Access Compliance Report Public Rights-of-Way (Curb Ramps)

Main Street: OAK_KNOLL_DR		Cross Street: WEATHERBY_RD		Location:	NW
ADA ID: RPRK211217134913	Ramp Type: Type 4 - Parallel	Initial Pass/Fail: Pass	Overall Compliance: No	Severity Score:	14
Codes/Mitigation Info/Possible Solution			Field Measurements/Component Compliance

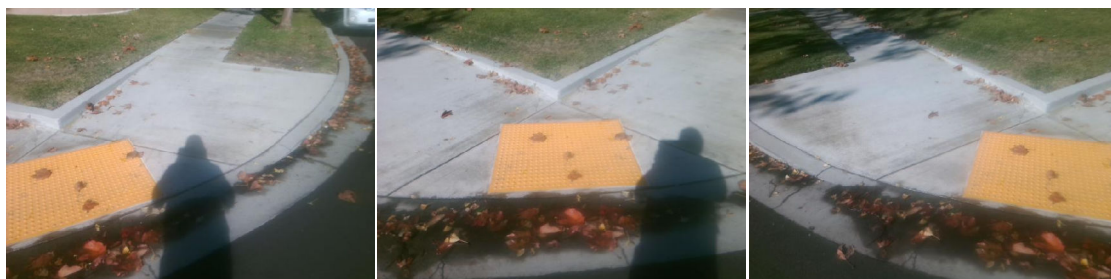
R304.2.1, R305.1.4, R302.7, R304.5.4, STD 1115

Remove & Replace Curb Ramp With Two New Directional Ramps or Equivalent. Remove & Replace Gutter.
